UNITED STATES
NUCLEAR REGULATORY COMMISSION

SAFETY EVALUATION BY THE OFFICE OF NUCLEAR REACTOR REGULATION
PROPOSED MODIFICATION FOR THE HATCH UNIT 2 CORE SHROUD
GEORGIA POWER COMPANY, ET AL.
EDWIN I. HATCH NUCLEAR PLANT, UNIT 2
DOCKET NO. 50-366

FIGURE 1 SHROUD HORIZONTAL WELDS

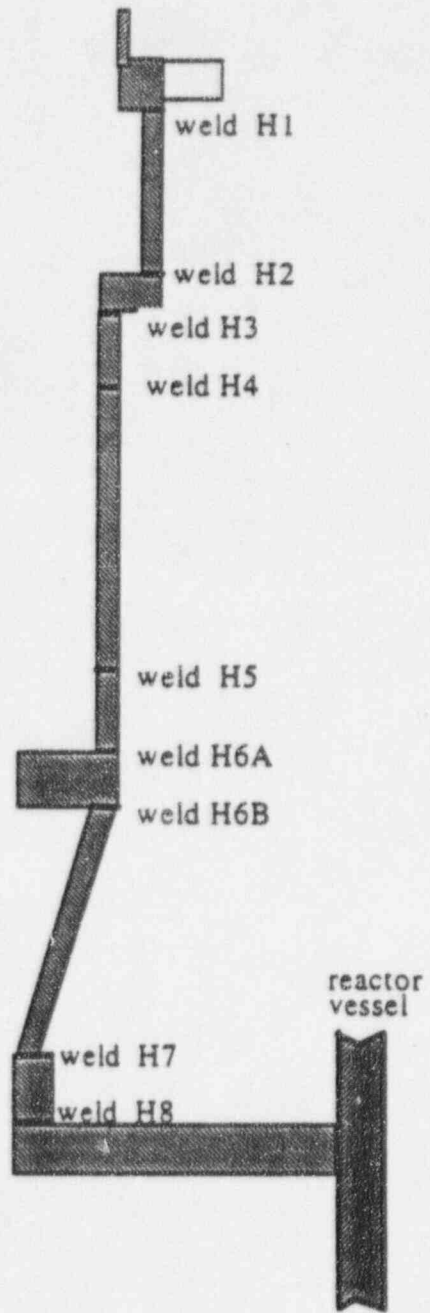
The function of the Unit 2 core shroud repair is to structurally replace all circumferential welds from the H1 weld at the top of the core shroud to the H8 weld at the bottom of the core shroud. The Unit 2 core shroud contains a total of nine circumferential girth welds. These welds are labeled H1 through H5, H6A, H6B, H7, and H8. (See Figure 1 for the identification of the core shroud welds.) The only significant cracking of BWR core shrouds has been associated with these welds.
